# Wollongong Local Planning Panel Assessment Report | 8 February 2022

WLPP	Item No. 2
DA No.	DA-2021/1310
Property	14-16 Acacia Avenue, GWNNEVILLE
Proposal	Residential – demolition of existing buildings, remove eight (8) trees, construction of multi dwelling housing – eight (8) units and Subdivision – Strata title – eight (8) lots
Applicant	10 Star Pty Ltd
Responsible Team	Development Assessment and Certification - City Centre Major Development Team (BH)
Prior WLPP meeting	20 October 2021

## ASSESSMENT REPORT AND RECOMMENDATION

**Figure 2: Revised Elevation (Internal)**

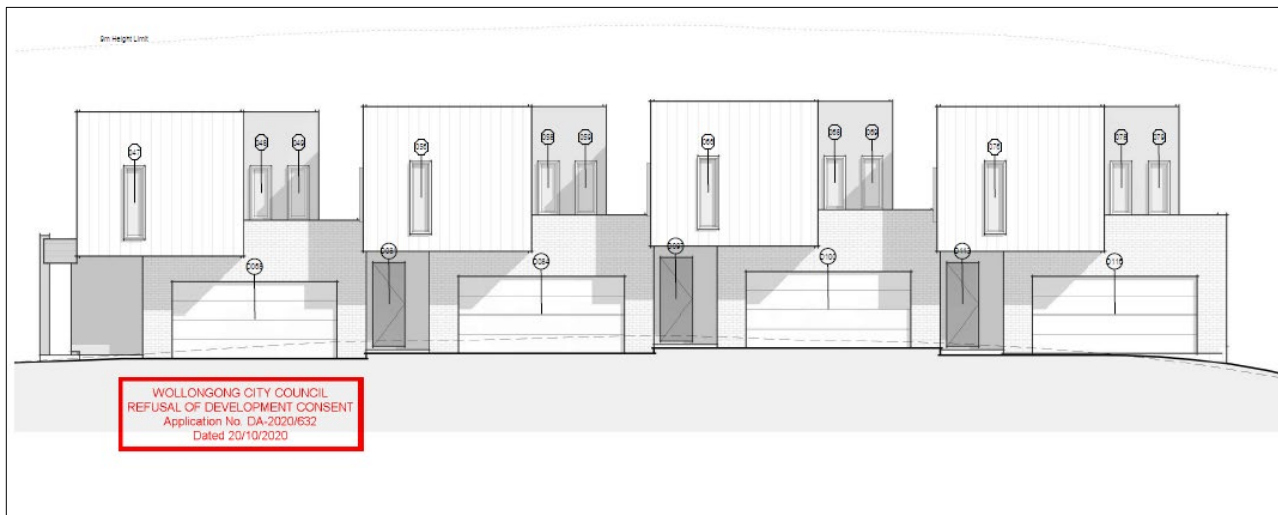
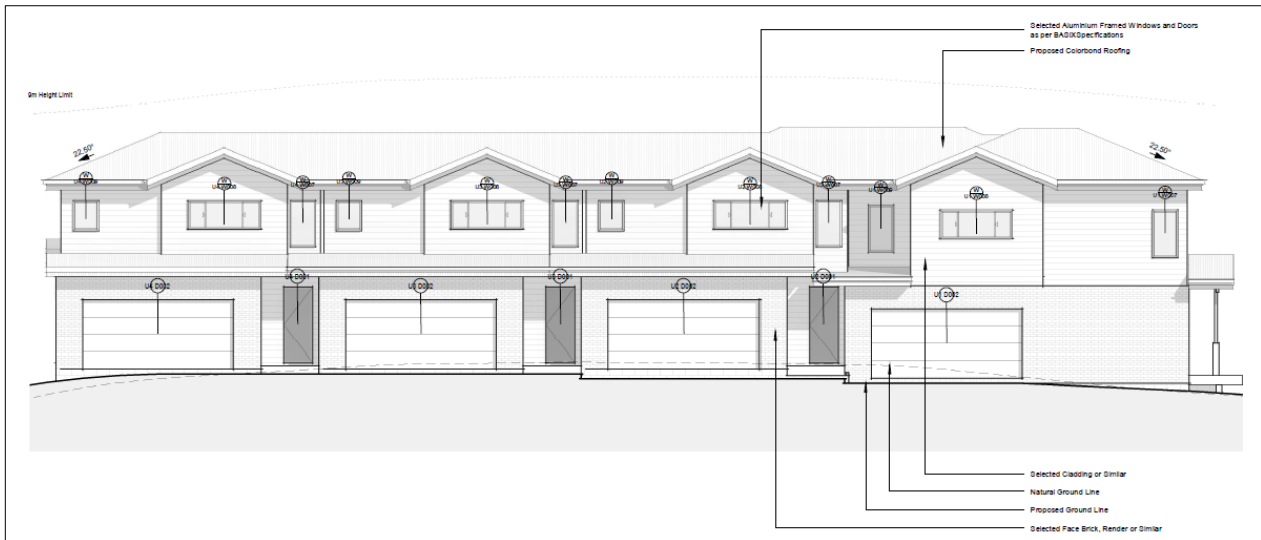
**6 Pursuant to the provisions of Section 4.15 (1)(b) of the Environmental Planning and Assessment Act, 1979, the external design of the proposal creates unnecessary bulk and scale both in terms of amenity for future residents and from a streetscape perspective.**

The proposal has been redesigned such that the previous 'modernist' built form with skillion roof forms and large sections of the first floor canter-levered over the driveway have been replaced with a more traditional hip and valley roof form. The upper floors in each 'block of units (ie 1-4 and 5-8) no longer provide a separation however this part of the original design provided no advantages to the units themselves in that they contained no windows. The redesigned upper floors remove the cantilevers over the driveway and now also provide a more appropriate internal layout with only the main bedrooms being provided with an ensuite.

Articulation of the external elevations has been increased to provide more depth and reduce the impacts from blank walls.

**Figure 4: Revised Streetscape Elevation**

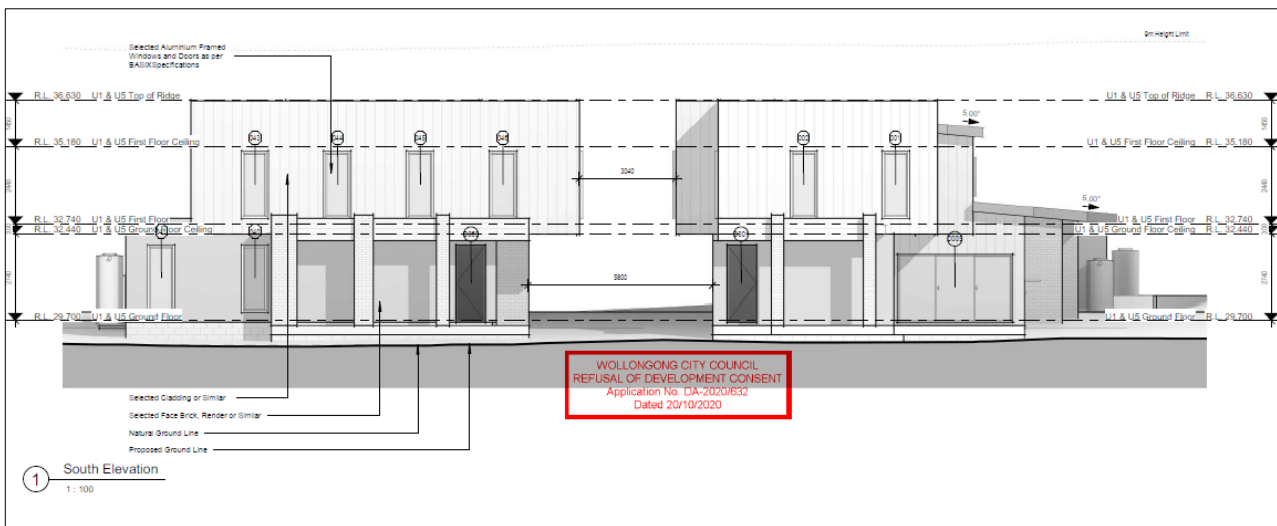
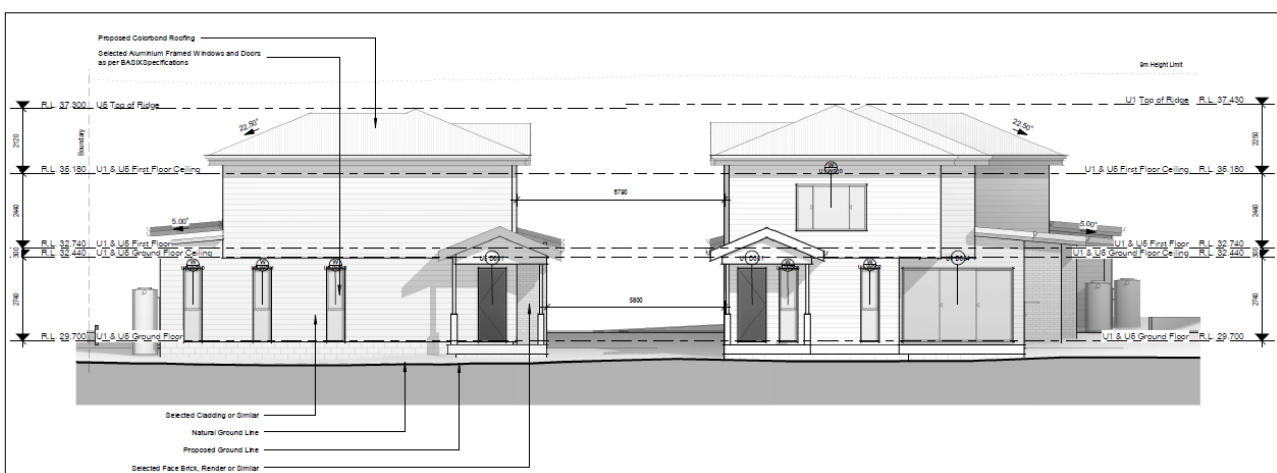
The front elevations of Units 1 and 5 which face the street now provide a more traditional appearance with clearly legible pedestrian entrances. This, together with a centrally located centrally located driveway accessing all units within the development is not inconsistent with a typical multi dwelling housing development and in its amended form the proposal presents a more appropriate built form appearance more in keeping with the existing character of Gwynneville.
